Piper Aircraft Corporation

**SUBJECT:** Gascolator Bowl Drain Valve

**MODELS AFFECTED:** PA-24 and PA-24 "250" Comanche Aircraft - Serial Numbers 24-2500 to 24-2700 inclusive

SERVICE BULLETIN #208

FUEL STRAINER DRAIN VALVE

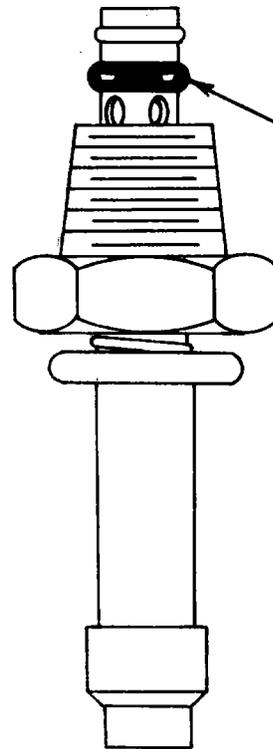
The failures have occurred as a result of machining the valve. The longitudinal hole drilled through the stem has penetrated the stem too deeply; thus weakening the stem adjacent to the "O" ring. It is requested that the valves installed in the aircraft indicated by the above serial numbers be inspected in the following manner:

1. Remove the belly access panel at the drain valve.
2. Look into the longitudinal hole in the valve stem and note if the cross-drill marks resulting from the cross-drilling of the stem adjacent to the "O" ring are visible.

Refer to the sketch on the reverse side of this Bulletin.

If the cross-drilling marks are observed, the valve may be considered satisfactory and no further action is required.

If the cross-drilling marks are not observed, the valve must be replaced.
